Authorized Field Change

AFC G-03901

Subject File: FRONT END SHEET METAL

Subject: Hood Lift Spring Bracket May Separate or Pull from the Mounting Area in 9900i and 9900ix Models Built Between April 19, 2001 and August 20, 2001

Figure 1 Remove Lift Spring Bracket With Spring Attached

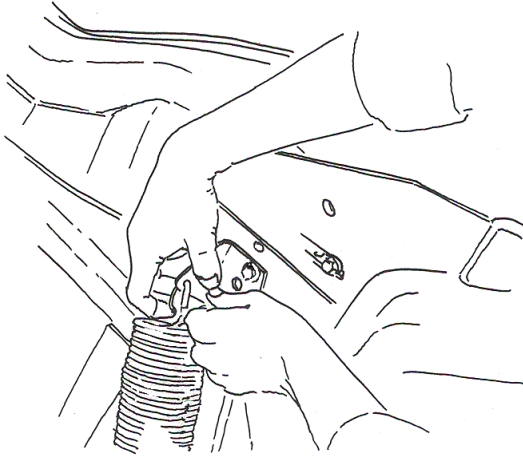
2. **9900i Model only:** Remove the hood bumper stop bracket and hood lift spring brackets, with the lift spring attached (Figure 1), from the hood. Remove the lift spring bracket from the lift spring (Figure 2). Identify the hood bumper stop brackets for driver and passenger side reassembly.
3. **9900ix Model only:** Remove the driver and passenger side hood lift spring brackets, with the lift spring attached, from the hood.

Figure 3 Install New Lift Spring Bracket (9900i and 9900ix Models)

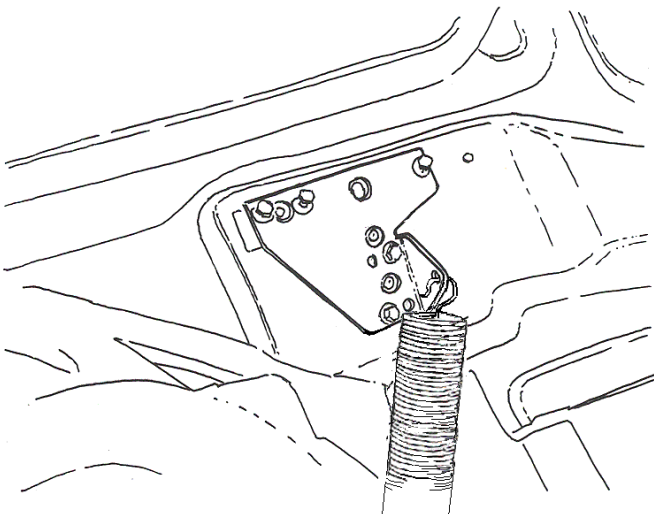
4. **9900i Model only:** Reinstall the hood bumper stop bracket with the new design hood lift spring brackets, with the lift spring attached (Figure 3 and Figure 4), to the driver and passenger side. Tighten the bolts to 15 Lbf-ft (20 Nm).
5. **9900ix Model only :** Install new design hood lift spring brackets, with the lift spring attached, to the driver and passenger side (Figure 3). Note, in addition to the original bracket bolts use two (2) Part Number 411431C2 bolts. Tighten to 15 Lbf-ft (20 Nm).
6. **9900i Model only:** Close the hood and check hood alignment. Adjust the hood stop bumper brackets as needed.
